ADDENDUM 04 – MADISON ES – 2 STORY CR BLDG **PBK**

Addendum No: 03
Project: Madison Elementary School – 2 Story Classroom Building
School District: Madera Unified School District
Prepared By: PBK Architects, Inc.
7790 N Palm Avenue
Fresno, California 93711
PBK Project No: 230278
DSA App No: 02-122191

Issue Date: 01/15/2025
To Drawings + Specifications dated 12/06/2024

CLIENT	MADERA UNIFIED SCHOOL DISTRICT	PROJECT NUMBER	230278	DATE	01/15/25
PROJECT	MADISON ELEMENTARY SCHOOL - 2 STORY CLASSROOM BUILDING	DSA APPLICATION NUMBER	02-122191	SCALE	
SHEET DESCRIPTION	DOOR AND WINDOW SCHEDULE	REFERENCE SHEET NUMBER	A2.1	SHEET NUMBER	4.1
DRAWN BY	Author

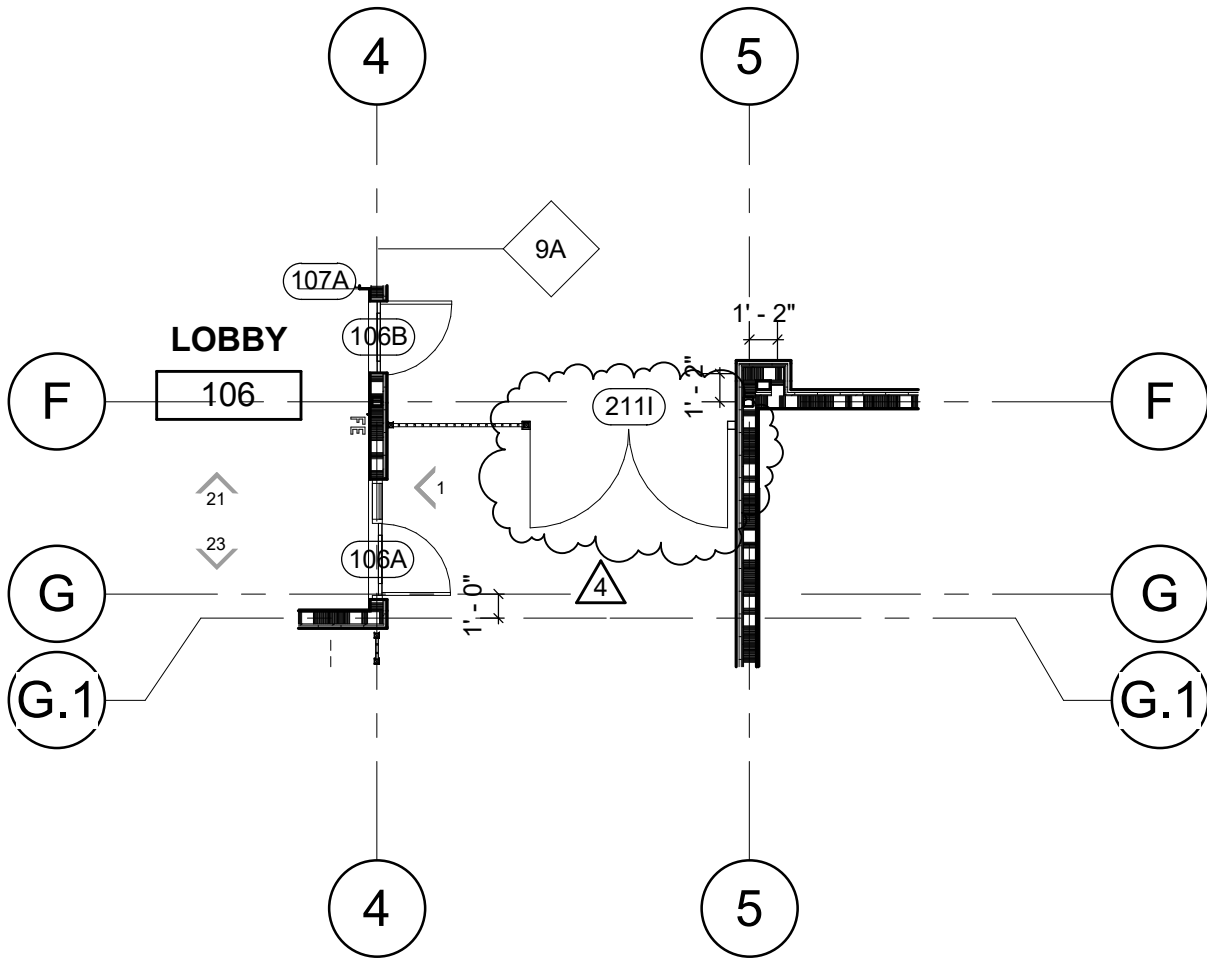
4.6 Refer to Sheet **A2.1 – Door and Window Schedule**, revise as follows:

- Revised Door Schedule items. Refer to sheet 4.1 – Door and Window Schedule (1 Page).
- Revised Door Types legend with dimensions and new type F. Refer to sheet 4.2 – Door and Window Schedule (1 Page).

CLIENT MADERA UNIFIED SCHOOL DISTRICT	PROJECT NUMBER 230278	DATE 01/15/25
PROJECT MADISON ELEMENTARY SCHOOL - 2 STORY CLASSROOM BUILDING	DSA APPLICATION NUMBER 02-122191	SCALE
SHEET DESCRIPTION FIRST FLOOR PLAN	REFERENCE SHEET NUMBER A1.1	SHEET NUMBER 4.3
DRAWN BY Author

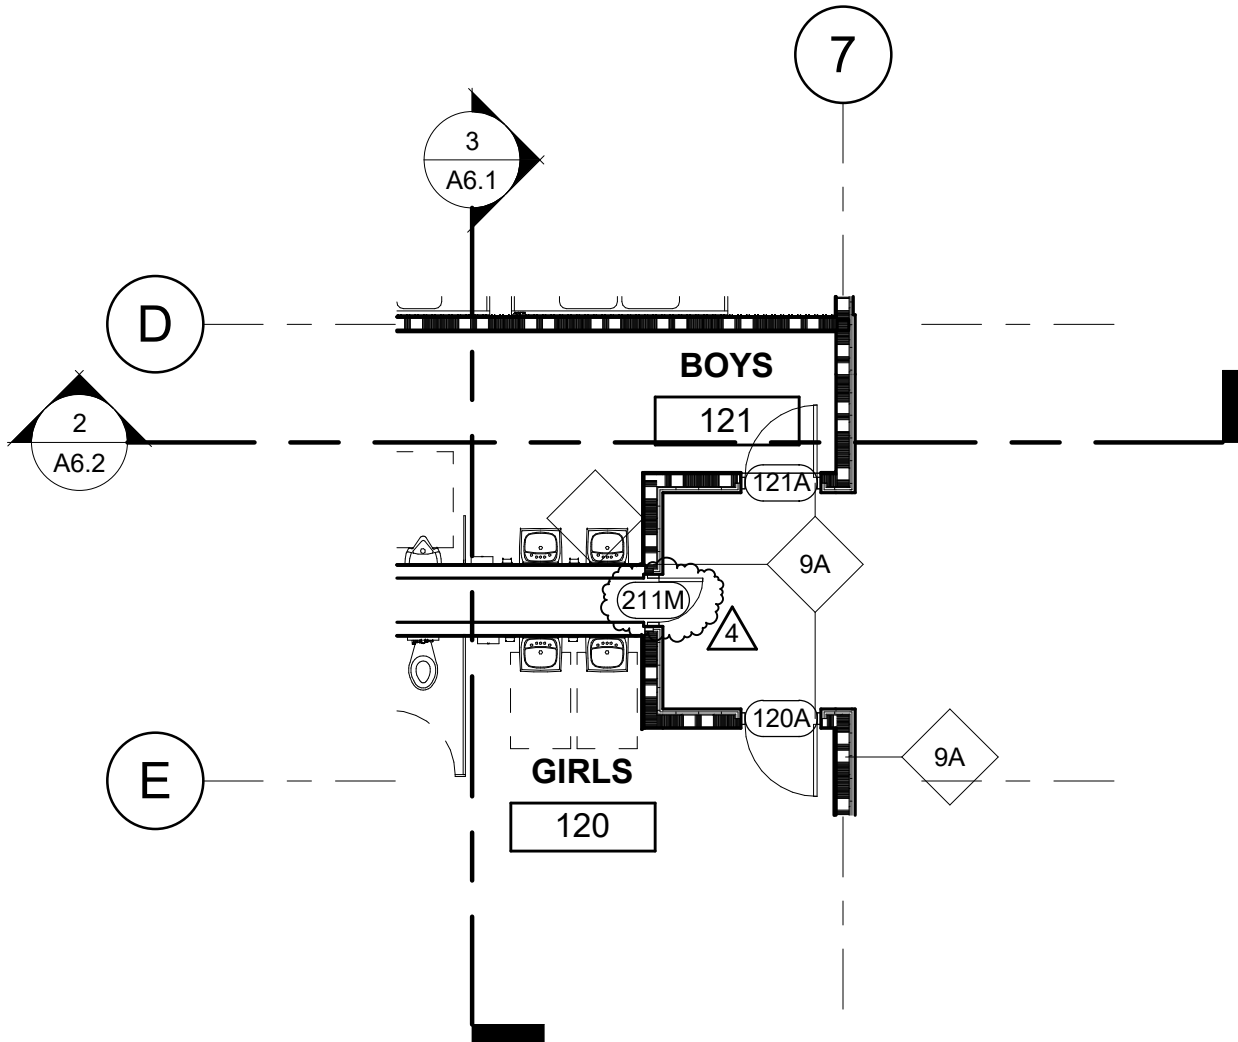
4.7 Refer to Sheet **A1.1 – First Floor Plan**, revise as follows:

- Added door tag 211I. Refer to sheet 4.3 – First Floor Plan (1 Page).
- Added door tag 211M. Refer to sheet 4.4 – First Floor Plan (1 Page).

CLIENT		PROJECT NUMBER	DATE
MADERA UNIFIED SCHOOL DISTRICT		230278	01/14/25
PROJECT		DSA APPLICATION NUMBER	SCALE
MADISON ELEMENTARY SCHOOL - 2 STORY CLASSROOM BUILDING		02-122191	
SHEET DESCRIPTION		REFERENCE SHEET NUMBER	SHEET NUMBER
INTERIOR ELEVATIONS		A7.1	4.6
DRAWN BY			
Author

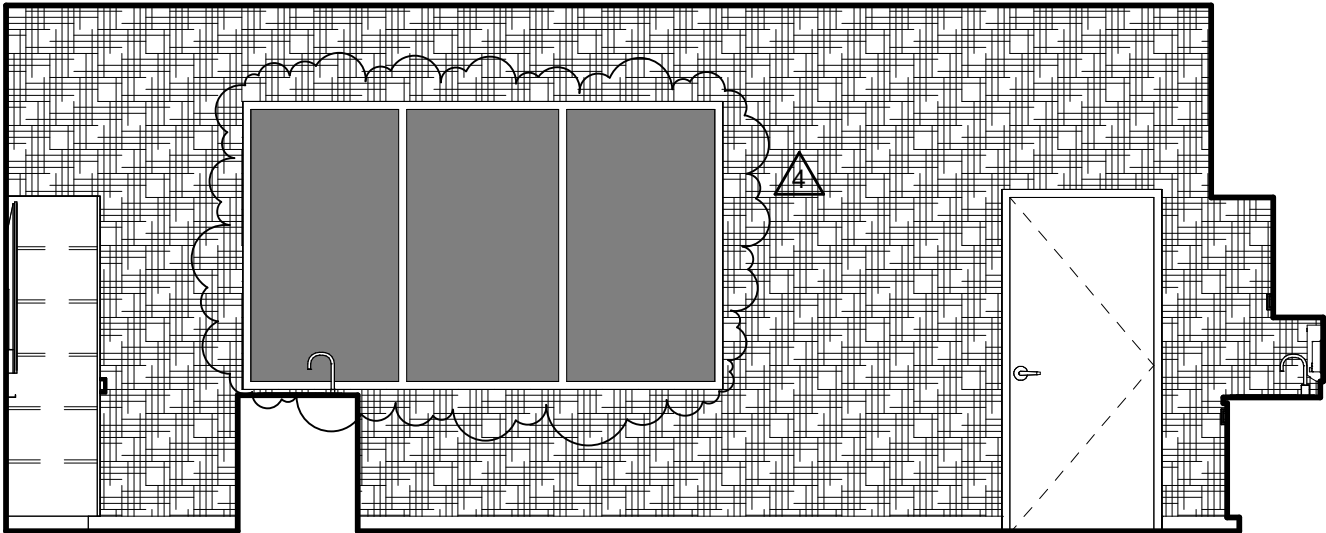
4.9 Refer to Sheet **A7.1 – Interior Elevations**, revise as follows:

- Revised interior elevation 15 for 104 CTE CLASSROOM. Refer to sheet 4.6 – Interior Elevations (1 Page).

CLIENT		PROJECT NUMBER	DATE
MADERA UNIFIED SCHOOL DISTRICT		230278	01/14/25
PROJECT		DSA APPLICATION NUMBER	SCALE
MADISON ELEMENTARY SCHOOL - 2 STORY CLASSROOM BUILDING		02-122191	
SHEET DESCRIPTION		REFERENCE SHEET NUMBER	SHEET NUMBER
INTERIOR ELEVATIONS		A7.2	4.7
DRAWN BY			
Author

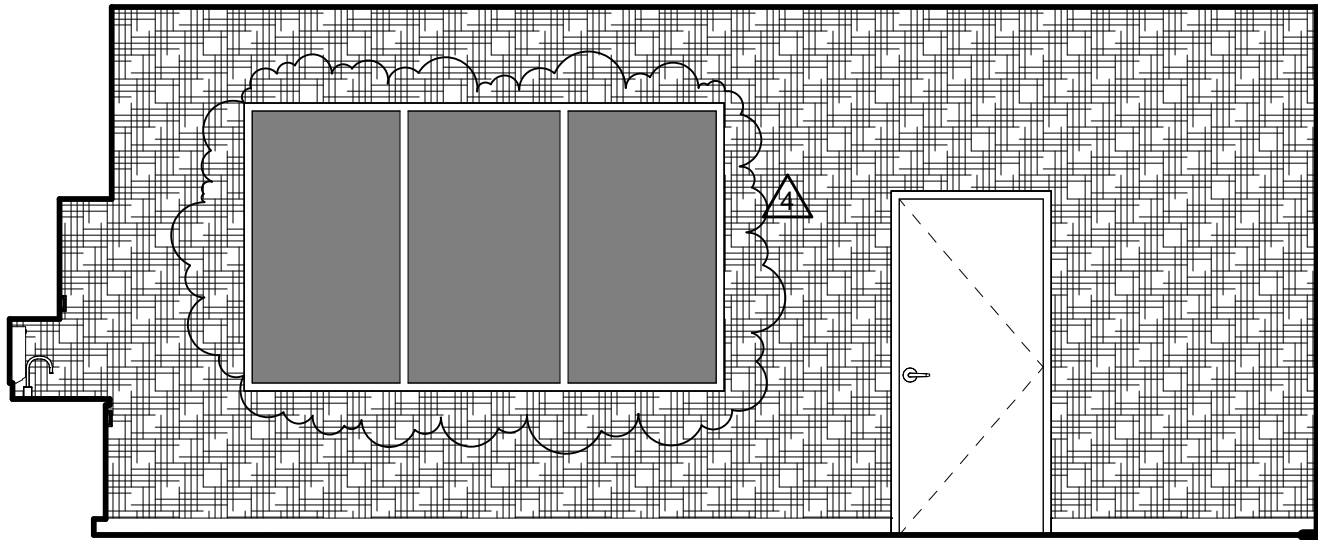
4.10 Refer to Sheet **A7.2 – Interior Elevations**, revise as follows:

- Revised interior elevation 19 for 105 VAPA CLASSROOM. Refer to sheet 4.7 – Interior Elevations (1 Page).

CLIENT		PROJECT NUMBER	DATE
MADERA UNIFIED SCHOOL DISTRICT		230278	01/14/25
PROJECT		DSA APPLICATION NUMBER	SCALE
MADISON ELEMENTARY SCHOOL - 2 STORY CLASSROOM BUILDING		02-122191	
SHEET DESCRIPTION		REFERENCE SHEET NUMBER	SHEET NUMBER
INTERIOR ELEVATIONS		A7.4	4.8
DRAWN BY			
Author

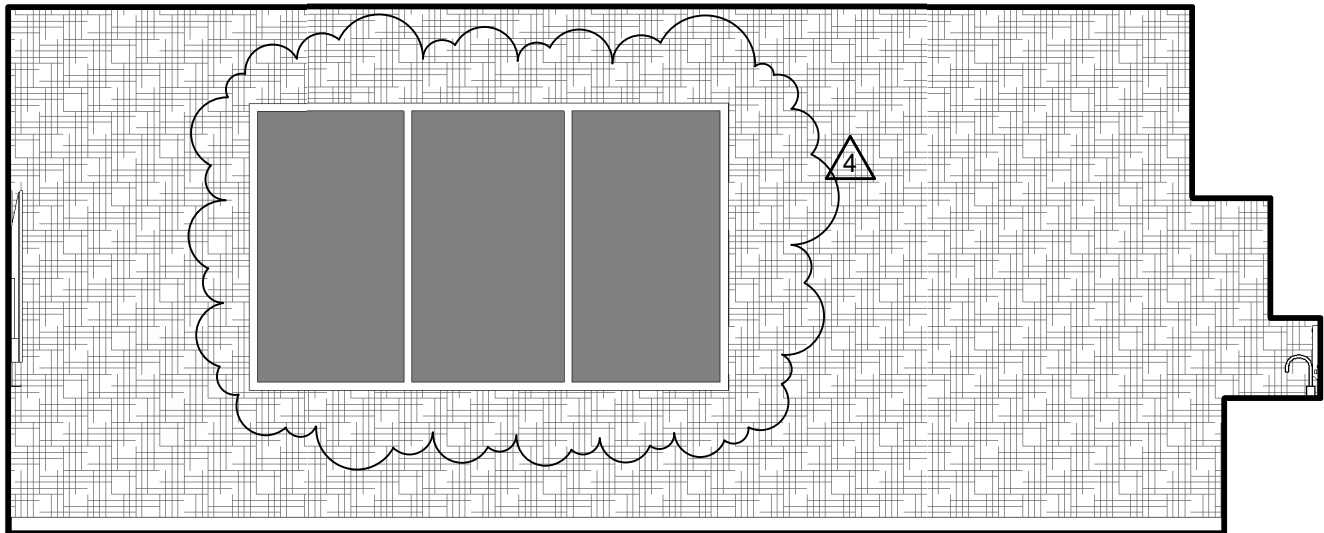
4.11 Refer to Sheet **A7.4 – Interior Elevations**, revise as follows:

- Revised interior elevation 19 for 205 CLASSROOM. Refer to sheet 4.8 – Interior Elevations (1 Page).
- Revised interior elevation 23 for 206 VAPA CLASSROOM. Refer to sheet 4.9 – Interior Elevations (1 Page).

Drawing: P:\2023\0209\Site Production\020903.DWG, 020903.DWG, CS2.1
P:\2023\0209\Site Production\020903.DWG, 020903.DWG, CS2.1
P:\2023\0209\Site Production\020903.DWG, 020903.DWG, CS2.1

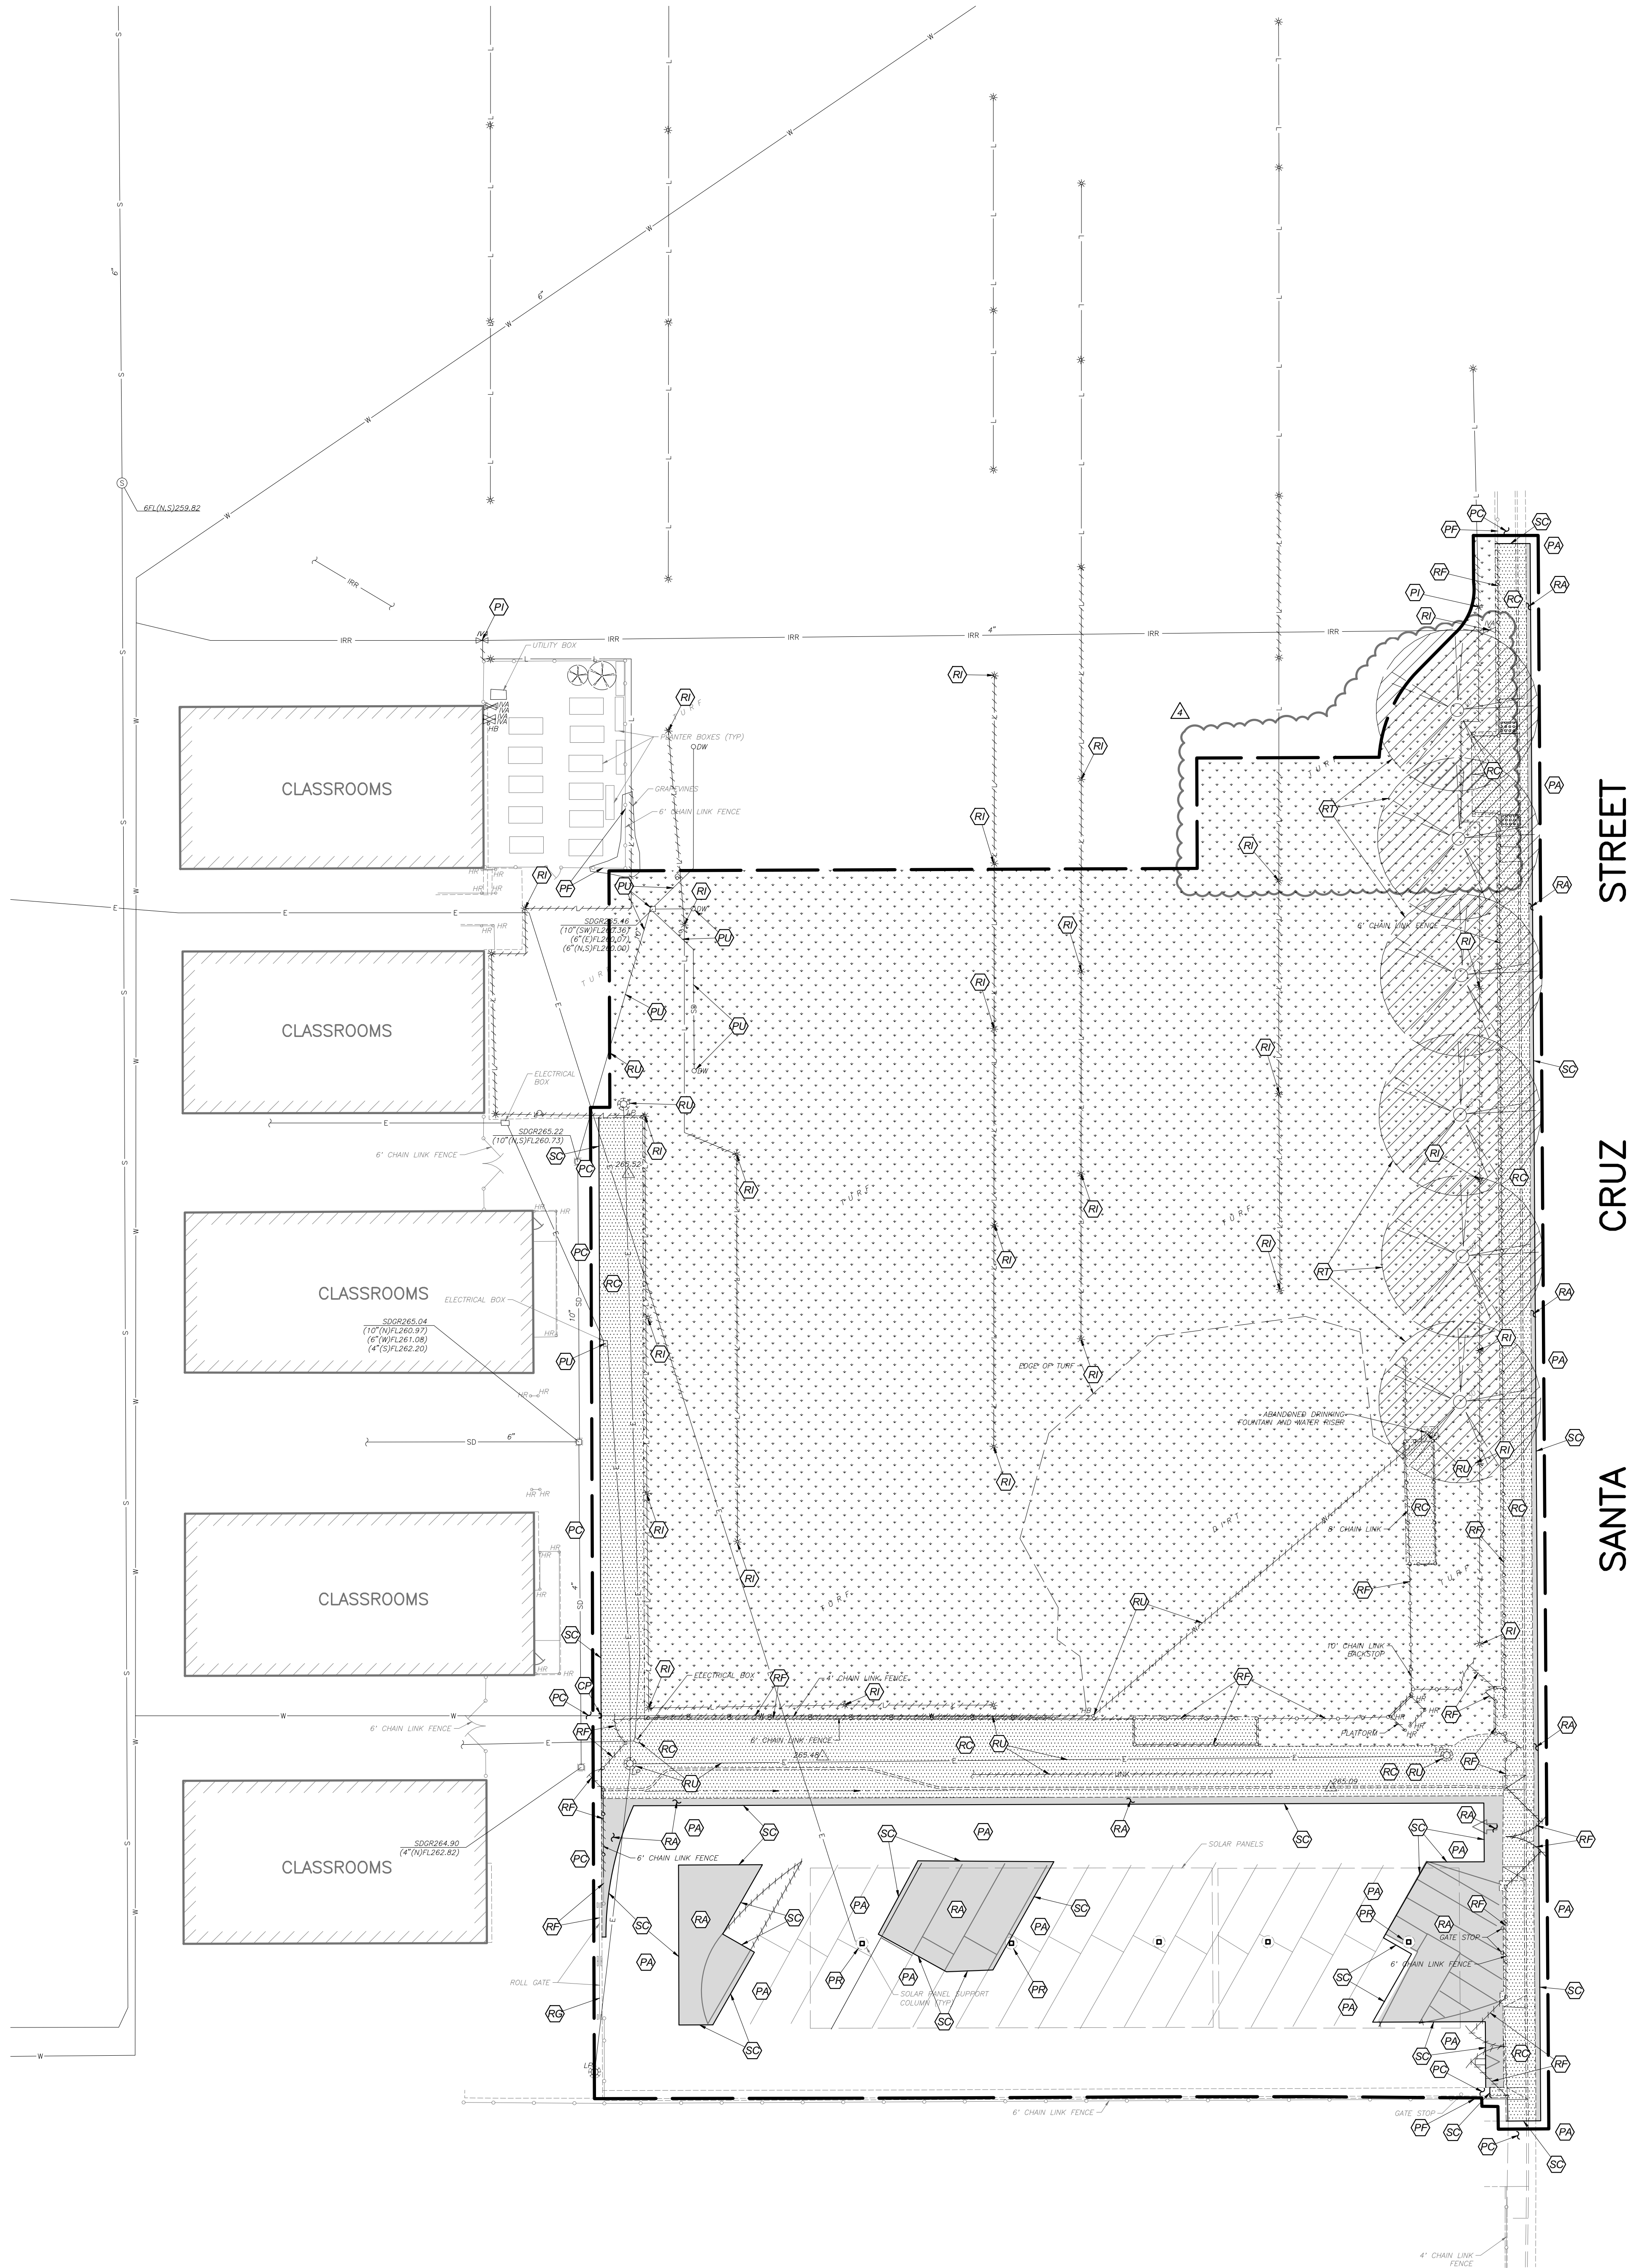
4.12 Refer to Sheet **CS2.1 – Demolition Plan**, revise as follows:

- Added removal of vegetation at fire access pad.
- Replace sheet with attached CS2.1 – Demolition Plan (1 pages)
